# **Attachment 1-A: Public Comments on IS/MND**

## Tract 8057 Residential Subdivision Project

Sulfur Creek Area of Concern

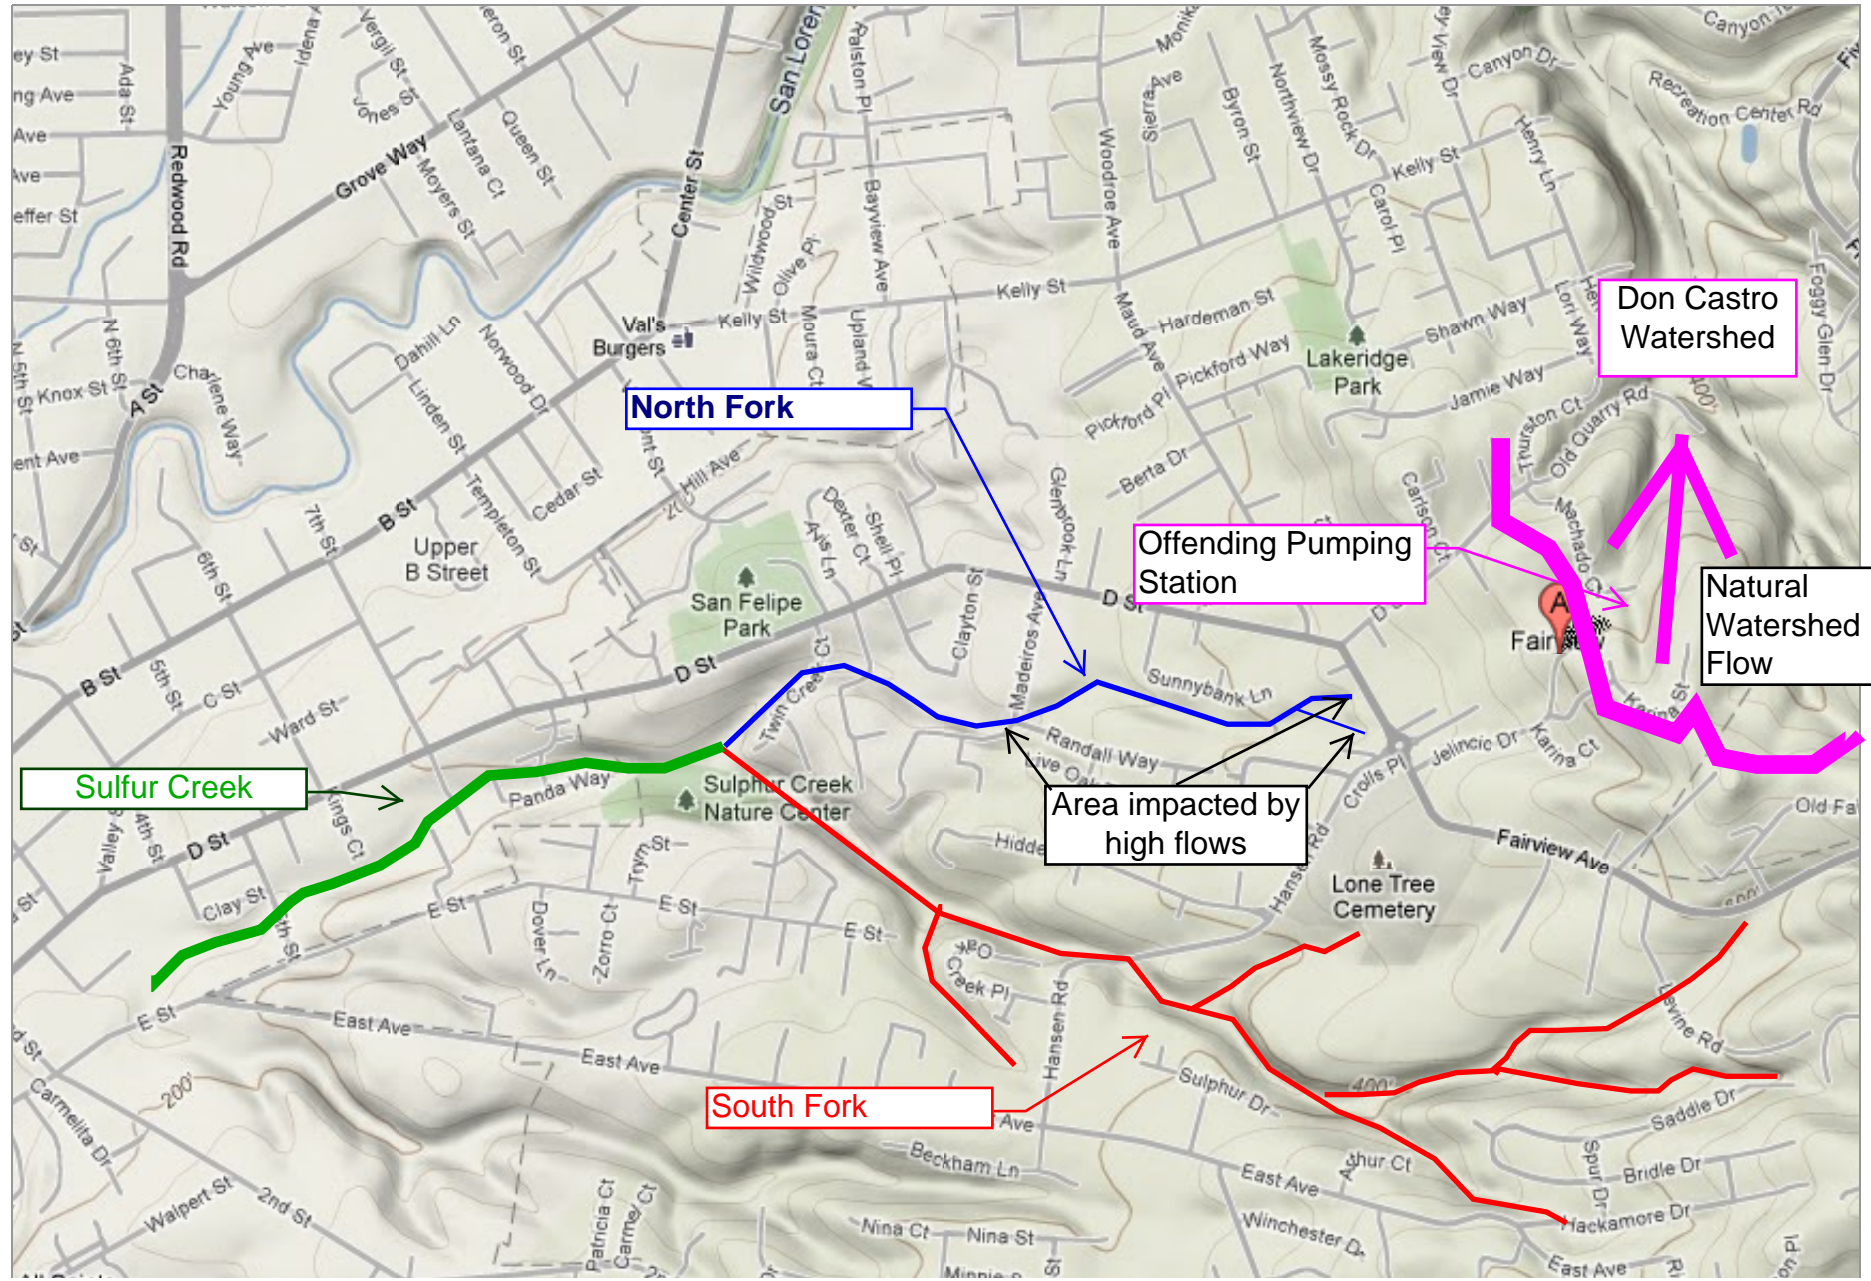
- 3) **Storm Water treatment.** The site spans 3 watersheds North Fork of Sulfur Creek, South Fork Sulfur Creek, un-named creek draining to Don Castro. It is not clear exactly where they propose to drop all runoff created by the development, but runoff from the access road and the entire side of the development facing the Sulfur Creek South Fork watershed will be dropped into existing storm drains that feed the North Fork of Sulfur Creek. This North Fork is already over capacity. In recent years this section of the North Branch has routinely left its banks flooding private property and washing over Madeiros Ave at its undercrossing. This seems to be occurring more frequently each year. We anticipate this will get worse as homes are built to complete the development above Jelincic Drive. That development has a storm water treatment plant that pumps runoff from the watershed of the un-named creek that drains to Don Castro, over the hill and into the North Fork of Sulfur Creek. The developer installed a detention facility to slow drainage for water that would normally flow into the North Fork of Sulfur Creek. Sadly this will not work because the storm drain intakes along the roads in the development were placed on the uphill side of the street. This is causing hardship on downstream homeowners.
